From: [RILEY, Jim](#)
To: [Miller, Ed](#); [Cook, Christopher](#)
Cc: [RILEY, Jim](#)
Subject: FW: dam failure white paper
Date: Tuesday, January 15, 2013 12:44:39 PM
Attachments: [Dam Failure Rev F DRAFT \(3\).docx](#)

POST-FUKUSHIMA NEAR-TERM TASK FORCE RECOMMENDATION 2.1
Supplemental Guidance for the Evaluation of Dam Failures

Post-Fukushima Near-Term Task Force Recommendation 2.1
Supplemental Guidance for the Evaluation of Dam Failures
January 14, 2013, Revision F

Figure 6 - Approach to Seismically-Induced Failure Evaluation

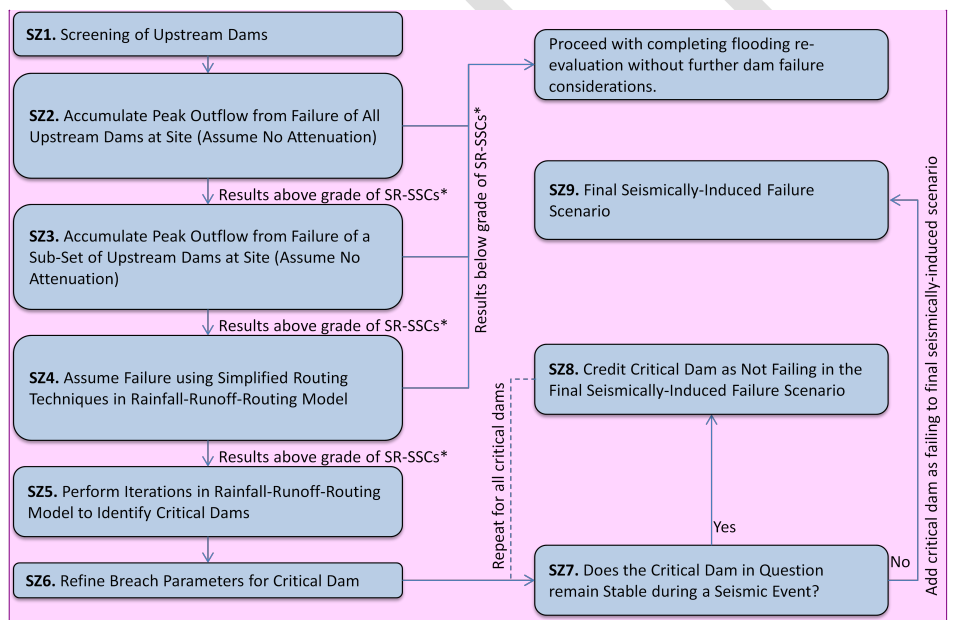
Comment [KSEE140]: In SZ-3 volume is not conserved.
 FFTF –need to discuss the comment, not sure of the intent

Figure 7 - Approach to Sunny-Day Failure Evaluation

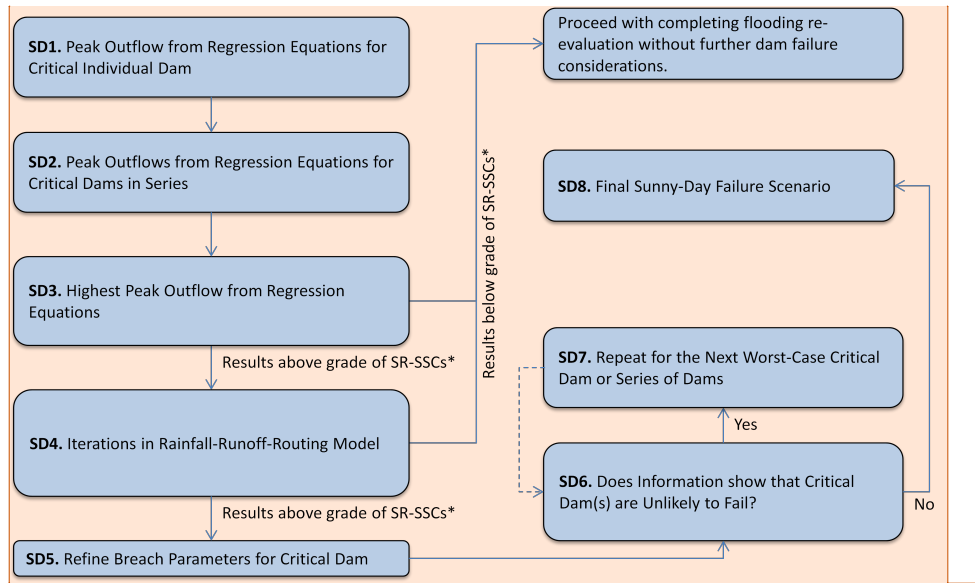
Comment [JFK167]: SD4 could be split into two pieces:
 SD4.1 – apply attenuation to dams from SD3
 SD4. Do the iterations if SD4.1 resulted in flooding above grade of SR-SSCs.
FFTF –OK will add a step between 3 and 4 to consider attenuation

Figure 8 - Peak Outflow as a Function of Height of Water behind Dam (Pierce 2010)

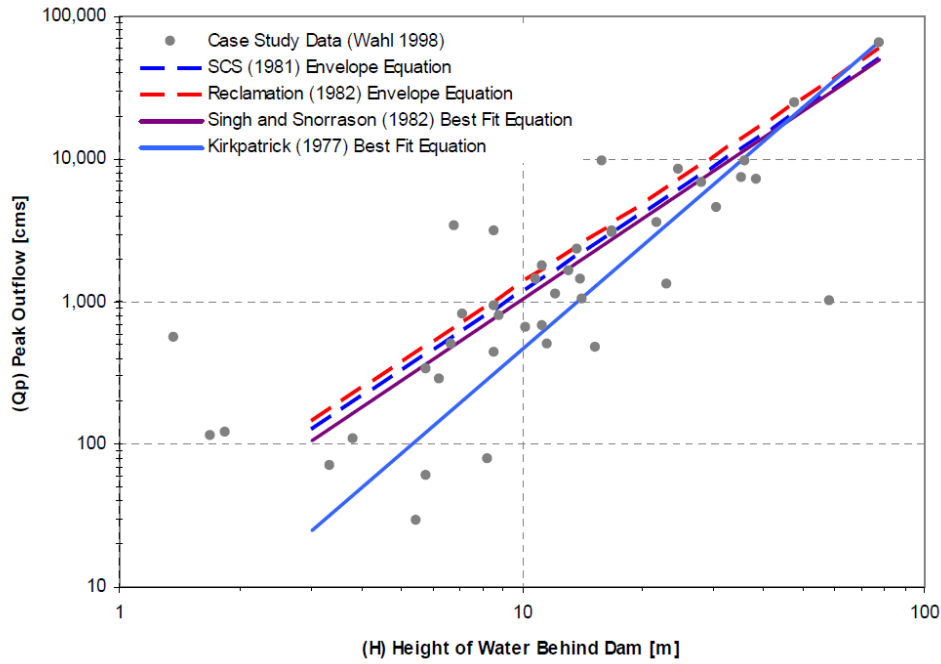
Comment [JFK190]: Not sure this figure is needed. It's not really discussed much.
FFTF – this is illustrative and was added to address comments from T Wahl. This should be kept in.

Figure 9 - Peak Outflow as a Function of Dam Factor (Pierce 2010)

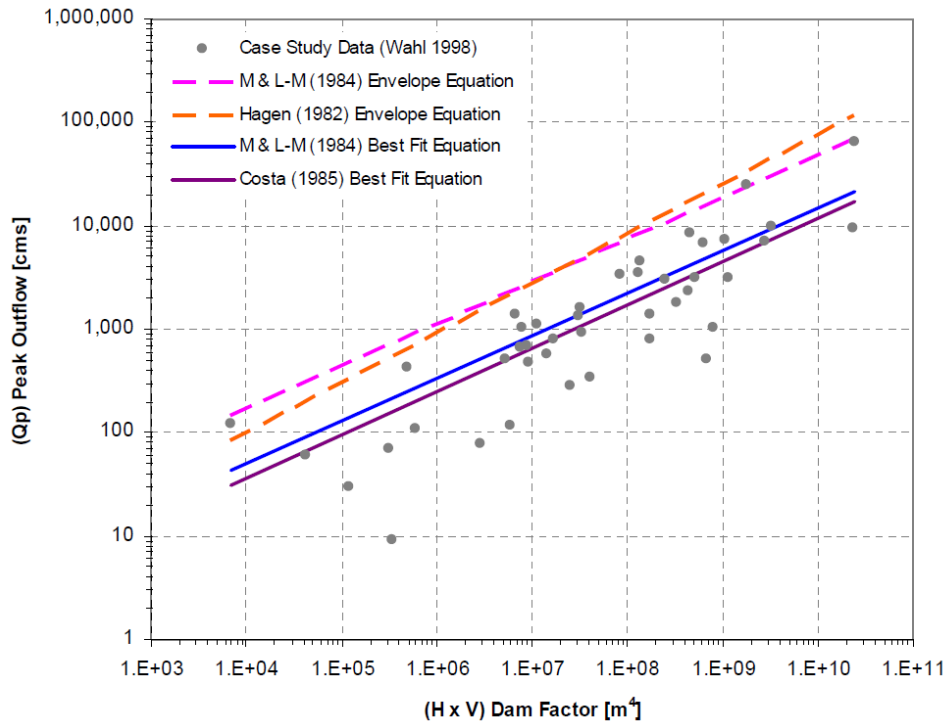
Comment [JFK191]: Consider removing figure. FTF – this is illustrative and was added to address comments from T Wahl. This should be kept in.
